Access Compliance Report

Public Rights-of-Way

(Curb Ramps)

Intersection ID: 30227	Main Street: CLARA_DUNN_LN	Cross Street: PATRICIA_RYAN_DR	Location: S
ADA ID: B4F7ED7FD963	Ramp Type: BlendTrans1	Initial Pass/Fail: Fail	Overall Compliance: No
Severity Score: 10			
Codes/Mitigation Info/Possible Solution		Field Measurements/Component Compliance

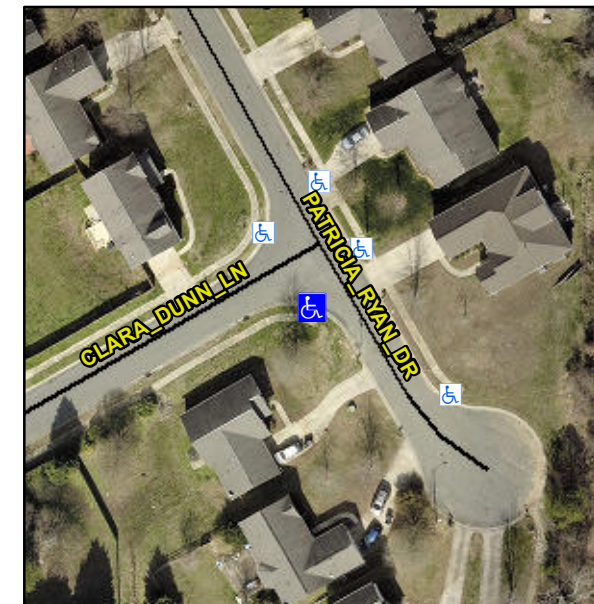
NO LT SW

Not Found, R304.5.1, R304.5.3

Compliance	Description	Data	Compliance	Description	Data
N/A	Ramp Length (in)	46.5	Yes	BlendTrans Slope (%)	3.1
No	Ramp Width (in)	42.5	No	BlendTrans XSlope (%)	4.0
N/A	Flare Type LT	N/A	N/A	Flare Type RT	N/A
N/A	Flare Slope LT (%)	N/A	N/A	Flare Slope RT (%)	N/A
N/A	Flare Traversable LT?	N/A	N/A	Flare Traversable RT?	N/A
N/A	Landing Length (in)	N/A	N/A	DWS Provided?	N/A
N/A	Landing Width (in)	N/A	N/A	DWS Contrast?	N/A
N/A	Landing Slope (%)	N/A	N/A	DWS Length (in)	N/A
N/A	Landing X Slope (%)	N/A	N/A	DWS Full Width?	N/A
N/A	Landing Curb? (Y/N)	N/A	N/A	DWS Offset (in)	N/A
N/A	Shared Landing?	N/A			
N/A	Gutter Ponding?	N/A	N/A	Gutter Slope (%)	N/A
N/A	Gutter Lip Ht (in)	N/A	N/A	Gutter X Slope (%)	N/A
N/A	Painted X Walk1?	No	N/A	Painted X Walk2?	No
	X Walk 1 Direction	To NW		X Walk 2 Direction	To NE
	X Walk 1 Width (in)	N/A		X Walk 2 Width (in)	N/A
	X Walk 1 Slope (%)	2.8		X Walk 2 Slope (%)	3.5
	X Walk 1 X Slope (%)	4.6		X Walk 2 X Slope (%)	0.6

N/A	Ramp inside XWalk1?	N/A	N/A	Ramp inside XWalk2?	N/A
	Road Slope (%)	3.5		Clear Space?	N/A
	Road X Slope (%)	0.8	N/A	Clear Space to XWalk (in)	N/A
N/A	Any Obstructions?	N/A	N/A	Storm Grate/Utility Hazard?	N/A
	Obstruction Type			Storm Grate/Utility Type	
		N/A			N/A
			Yes	Surface Condition? (G/P)	Good
			No	Curb Slope (%)	16.3

Remove & Replace Curb Ramp With Two New Directional Ramps or Equivalent.
